3. Number  
WHC-SD-W011H-ES-002

HUMIDITY REQUIREMENTS OF WSCF LABORATORIES

#### 5.0 SIGNIFICANT PEER REVIEW COMMENTS

Sketch from Comment and  
Cost Estimates

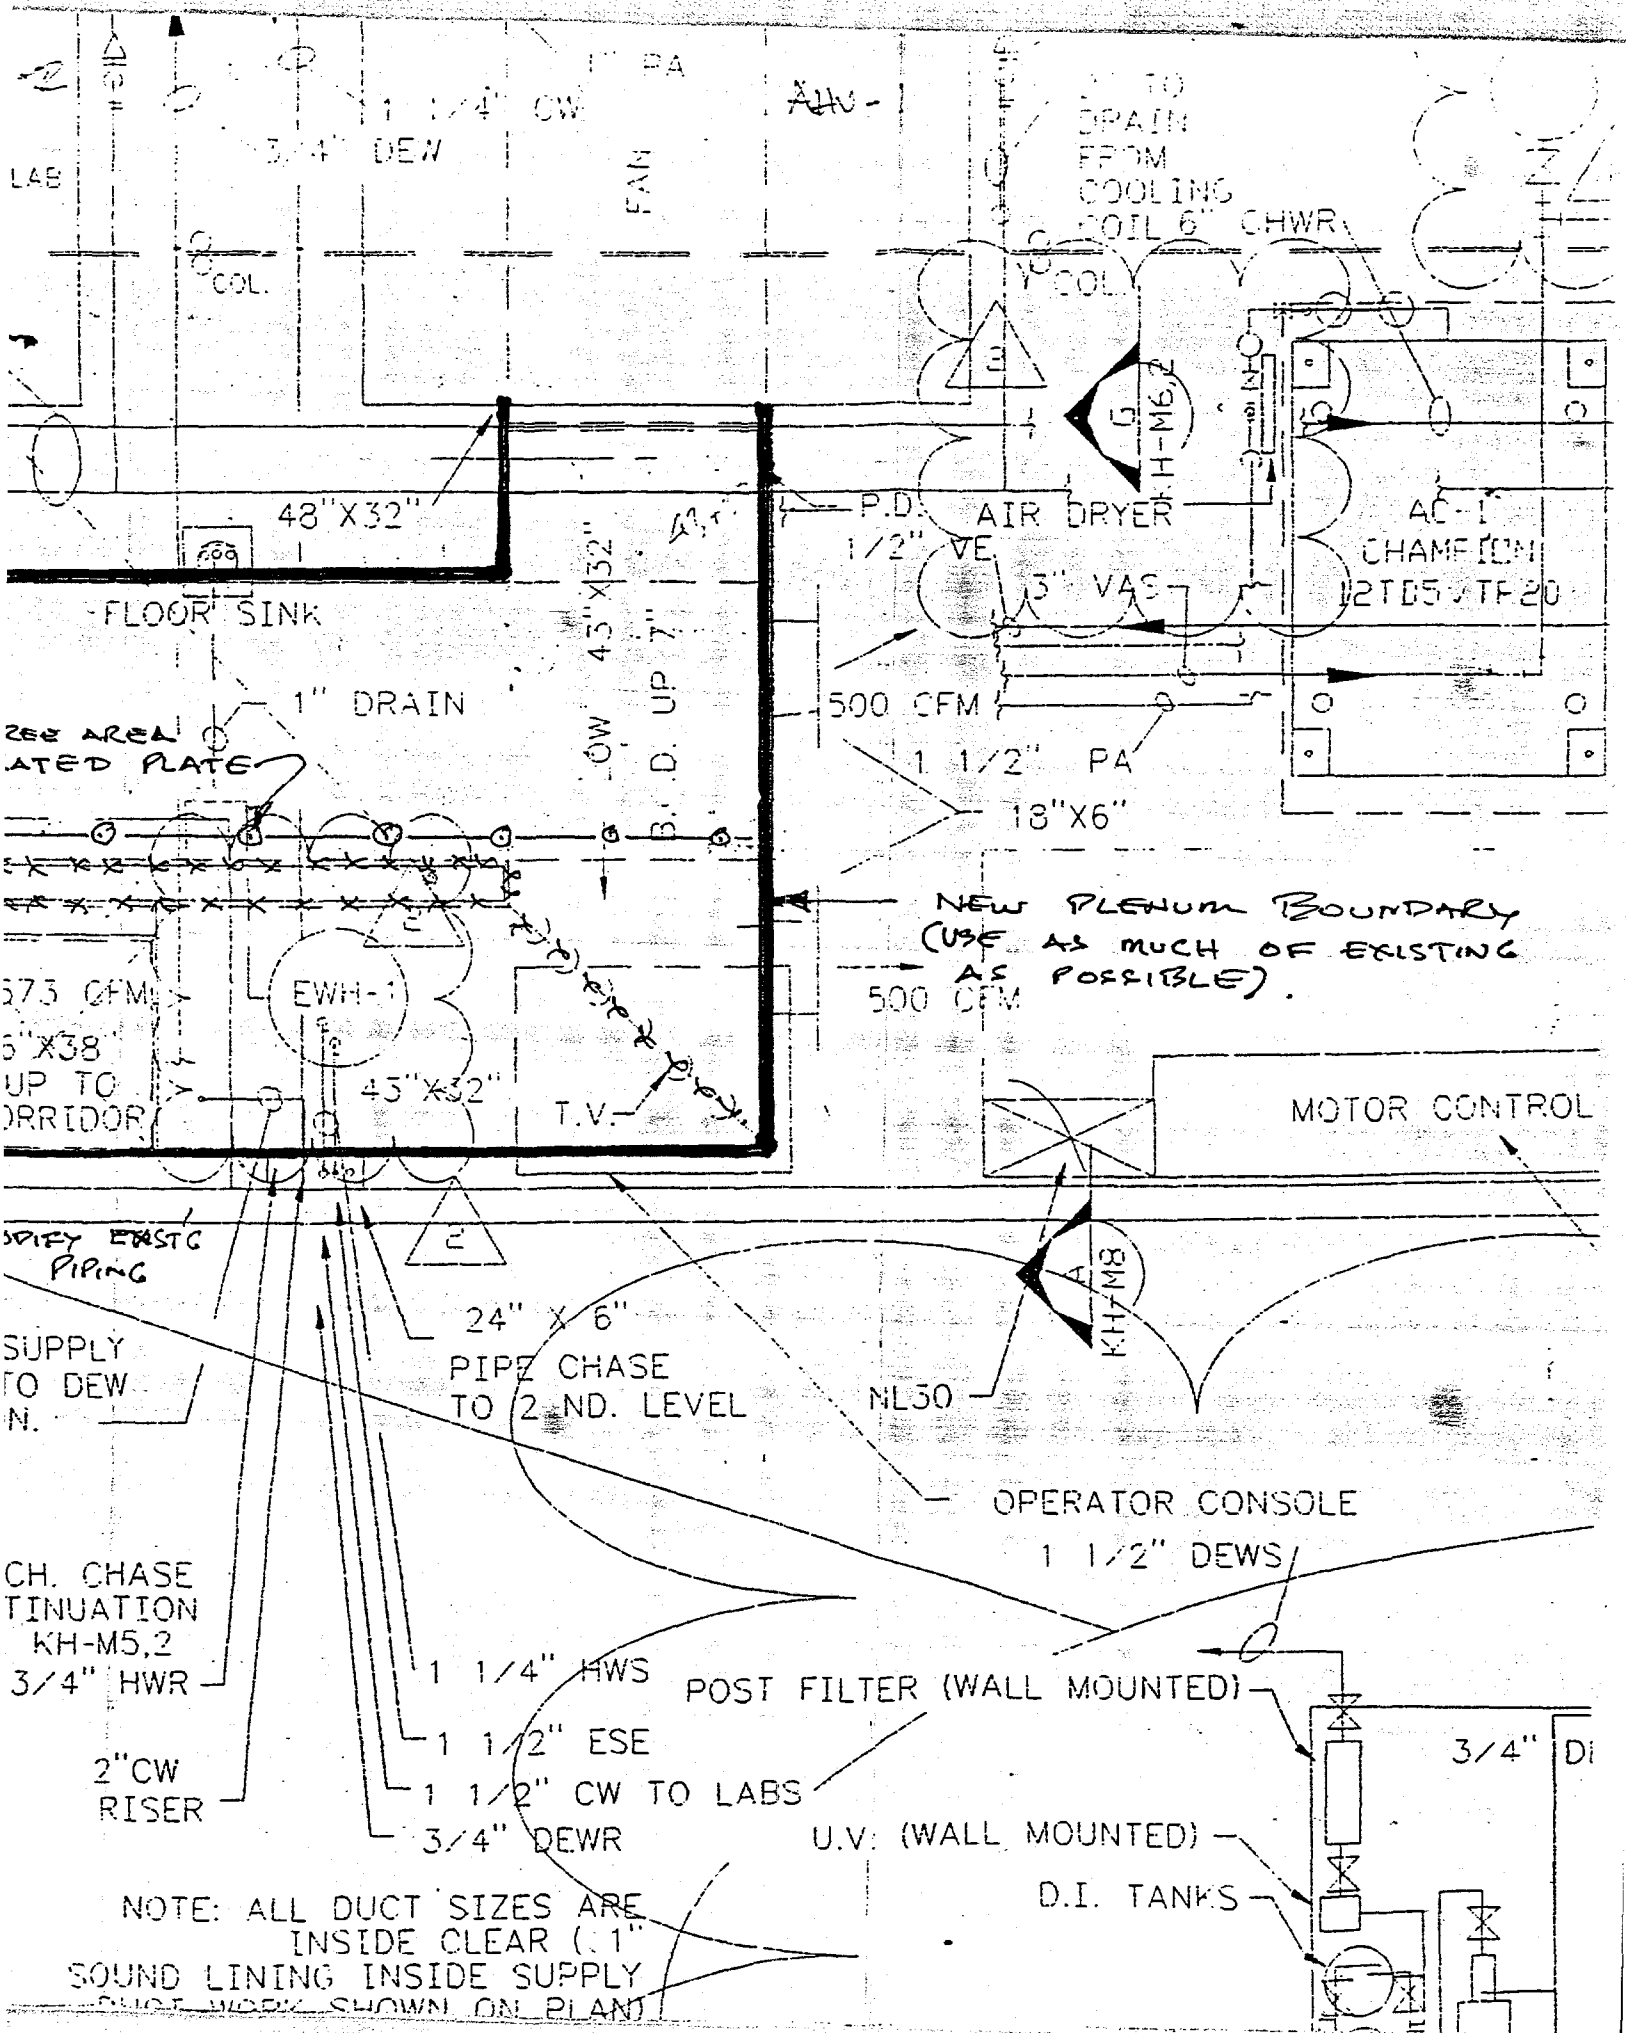
Consider an Option 4: What would be the cost of rearranging the air handling units to accommodate a humidifier upstream of the cooling coils and downstream of the heat recovery system and the electrical heaters?

Proj. DWG. H-6-1733	Sh. 2	Rev. 2	Prepared By <i>[Signature]</i>	Checked By <i>[Signature]</i>	ECN No. W-Φ 11H-280	Page 6
------------------------	----------	-----------	-----------------------------------	----------------------------------	------------------------	-----------

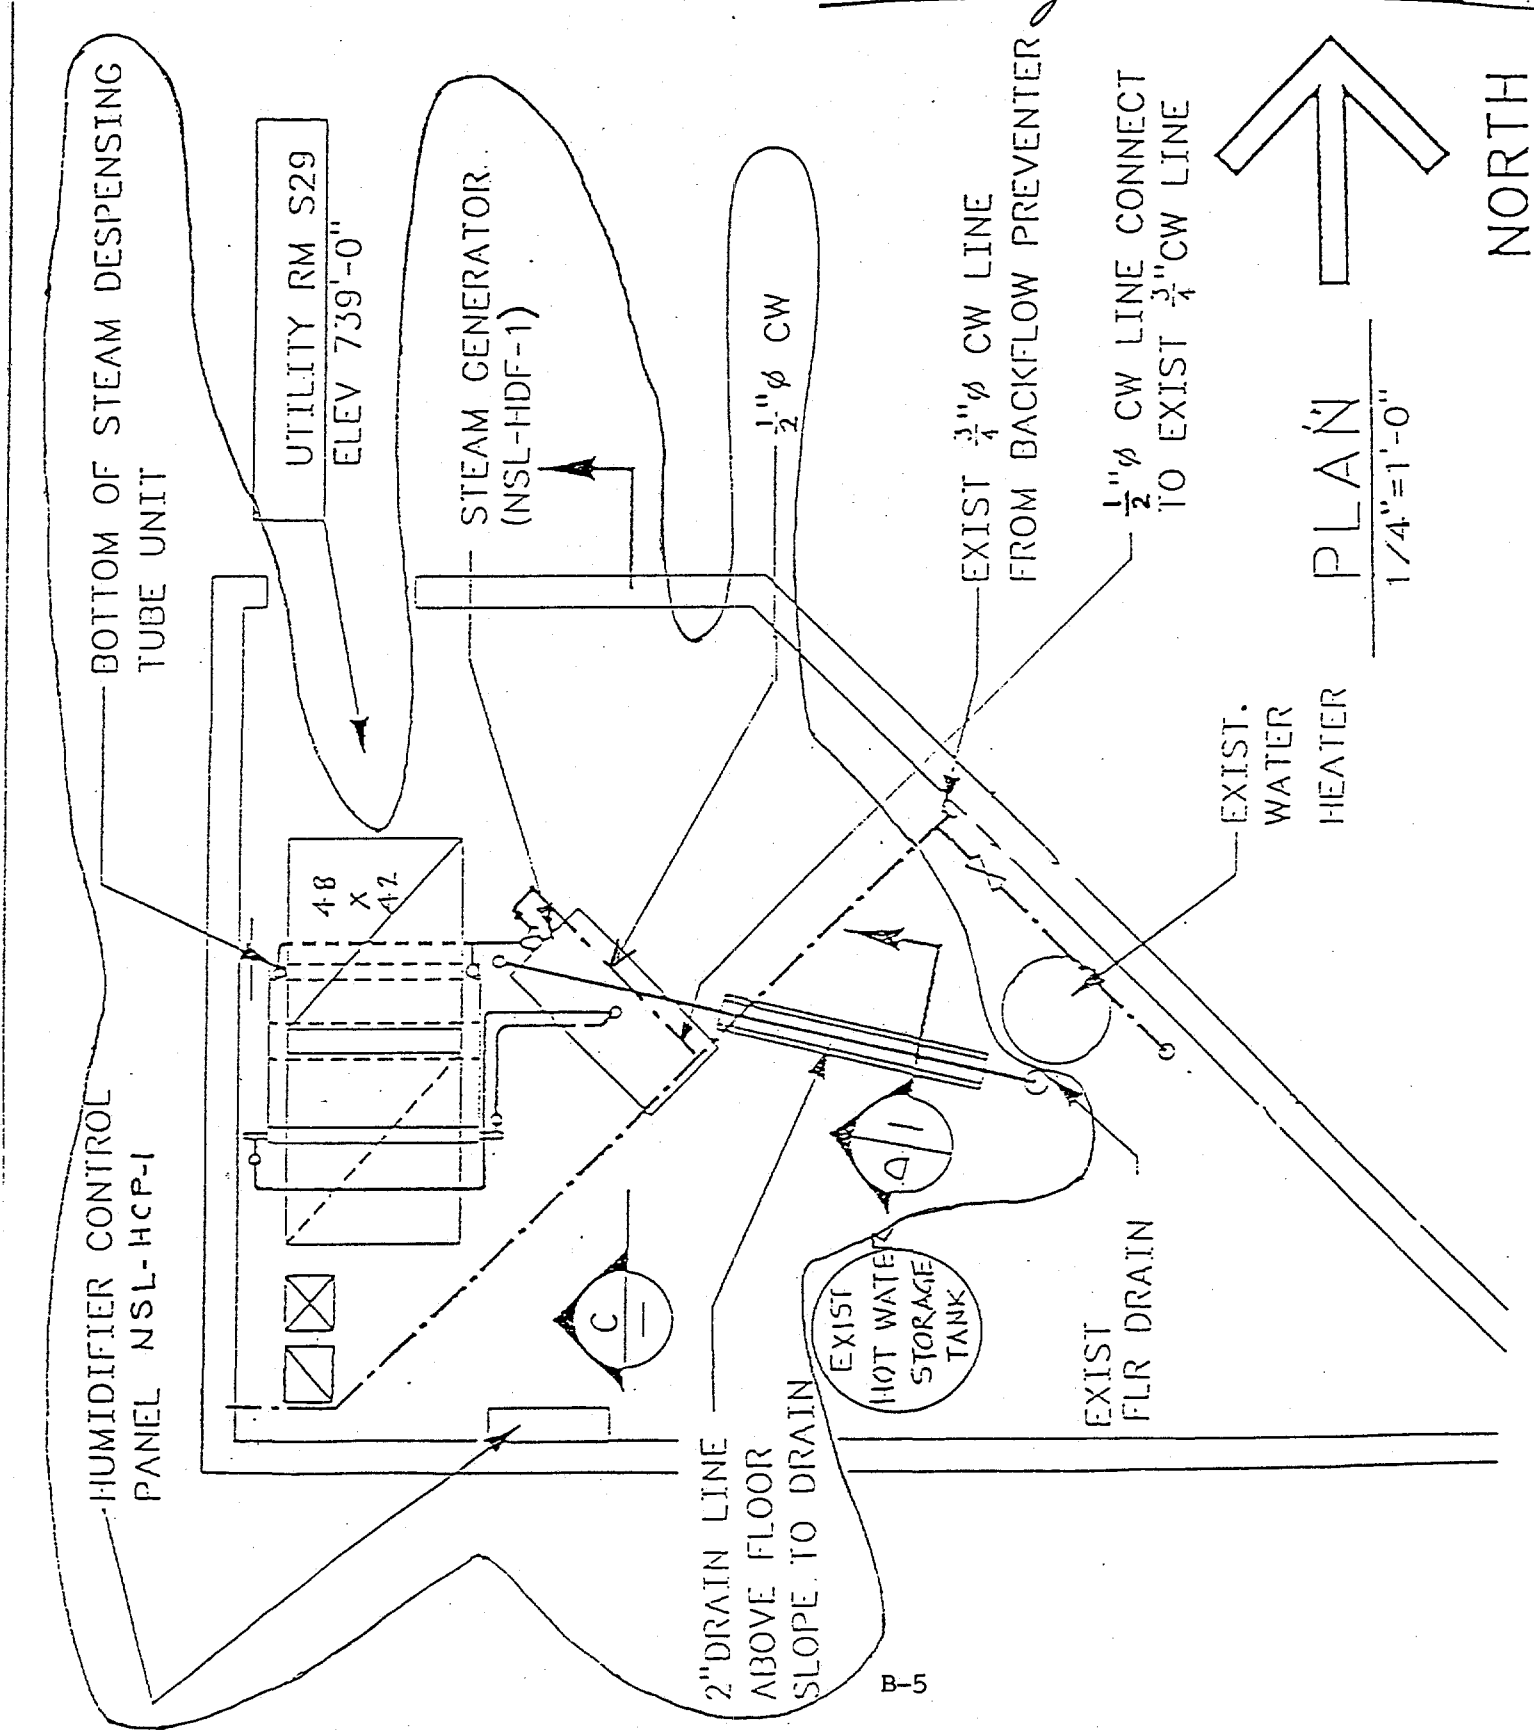
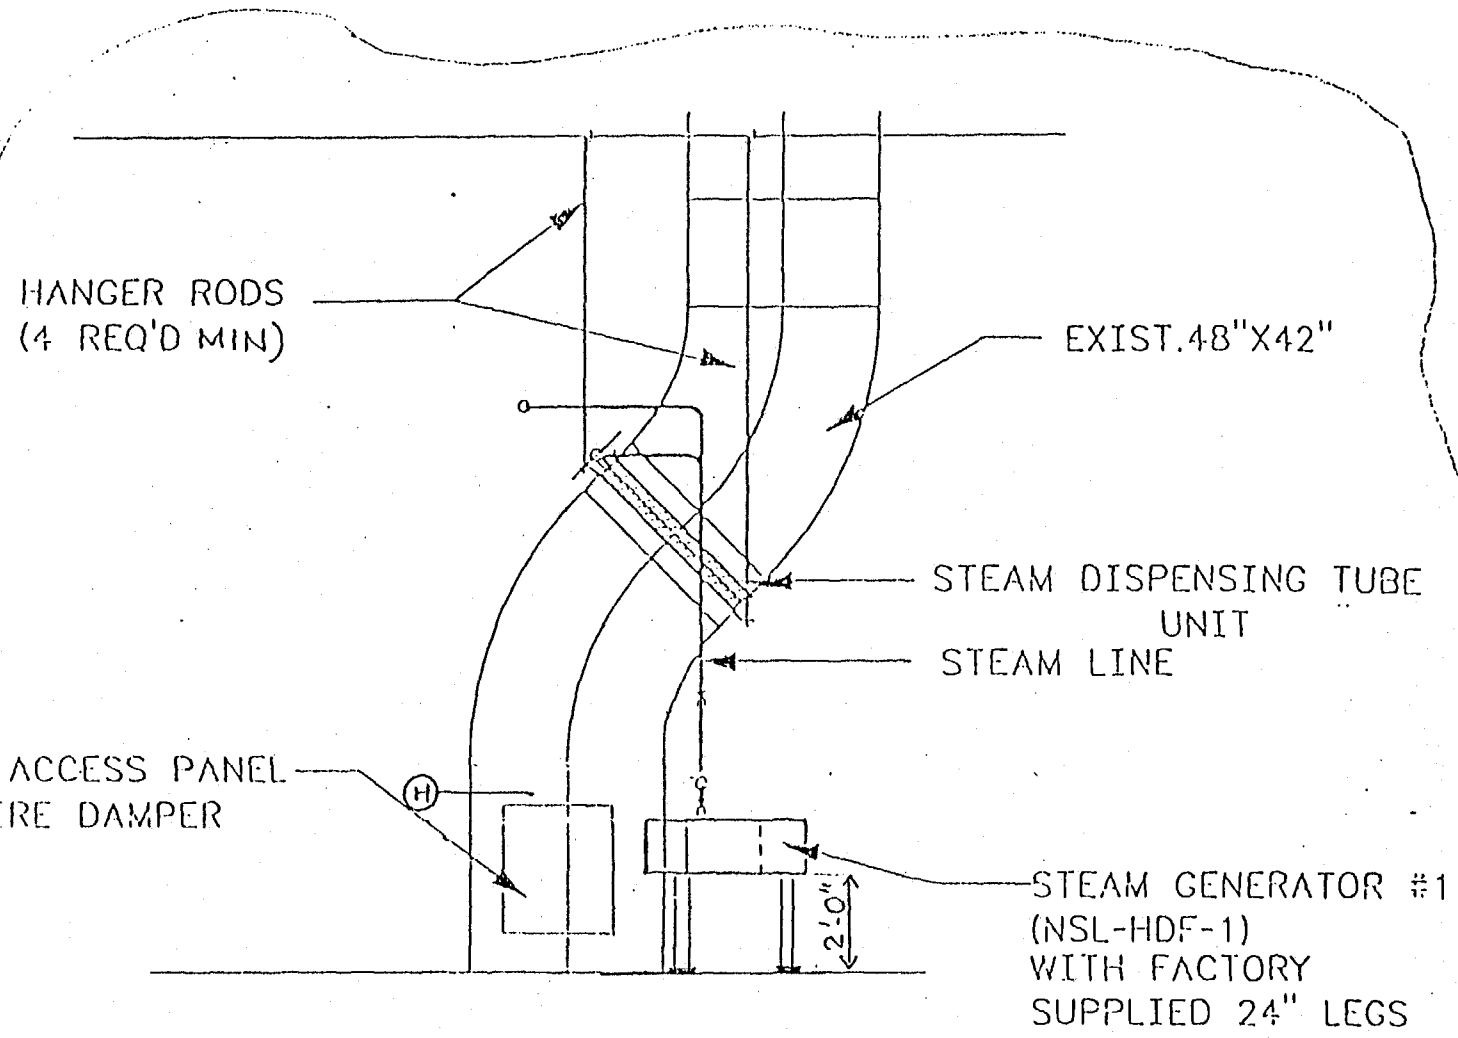
PROVIDE AND INSTALL A COMPLETE, AUTOMATIC STEAM HUMIDIFICATION SYSTEM AS SHOWN IN THIS ECN.

Ref. Dwg. H-6-1738	Sh. 2	Rev. 2	Prepared by: M. GORJI	Checked by: <i>[Signature]</i>	ECN No. W-011H-281	Page 4/4
-----------------------	----------	-----------	--------------------------	-----------------------------------	-----------------------	-------------

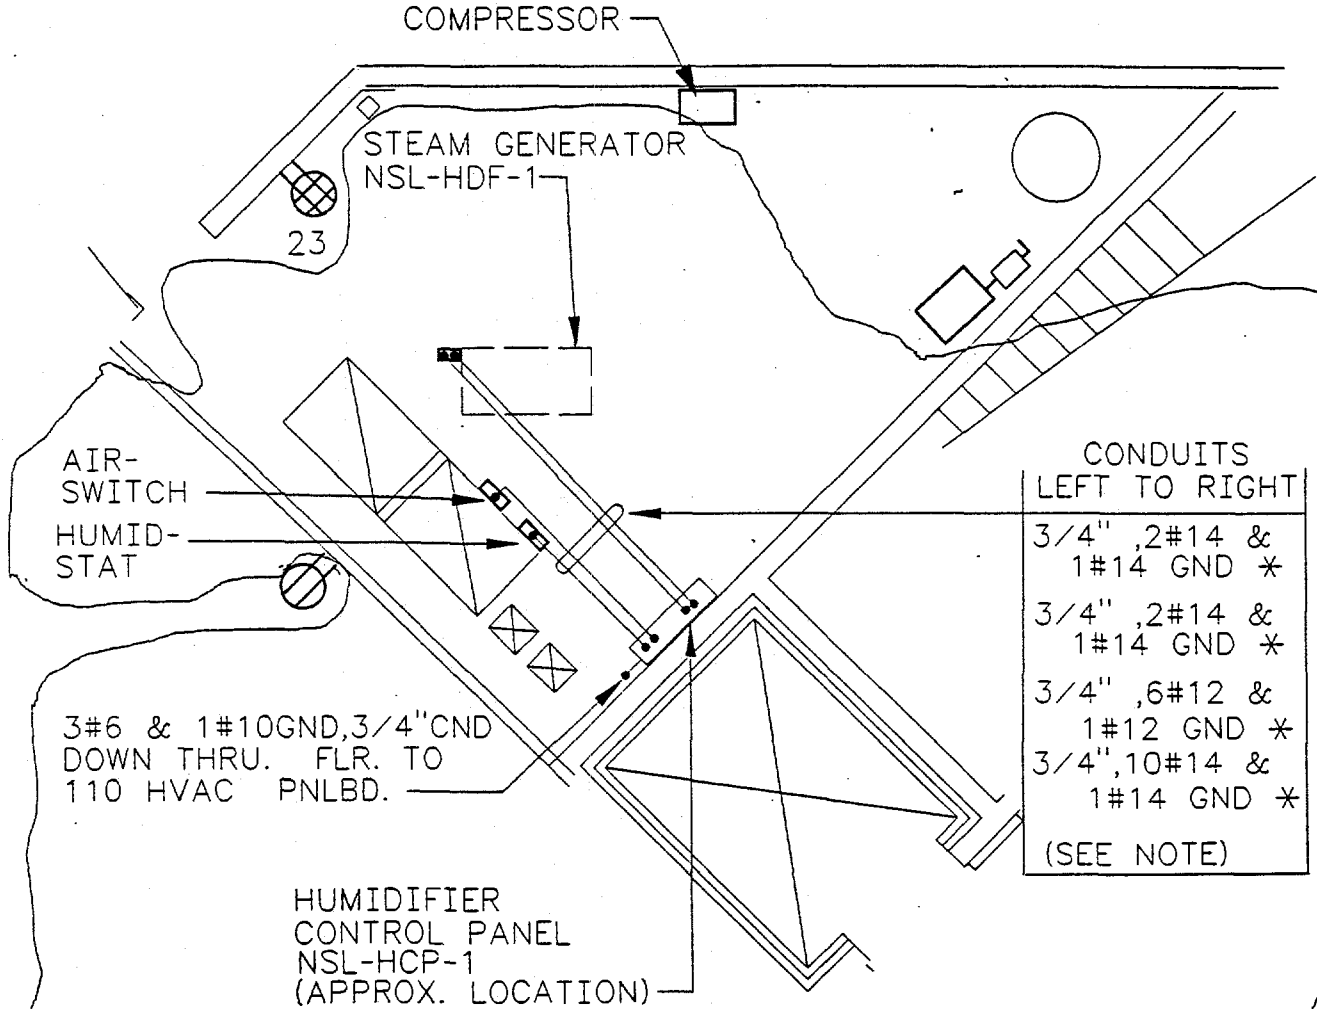
12. Description of Change  
documents affected:  
 H-6-1737 SH1, REV. 2 AND H-6-1738 SH2, REV. 2.  
 1. Revise per the attached sheets 3 AND 4.

13b. Justification Details  
 The new NSL humidifier (ONE at 32 KW) requires a 50-ampere, 3-phase, 480 volts feeder. A new 100-ampere frame size, with 50-ampere trip rating, circuit breaker is added to 110 HVAC panel to supply 480-volt, 3-phase power to humidifier control panel. The humidifier is interlocked with NSL HVAC system through a new air switch to be furnished by vendor.
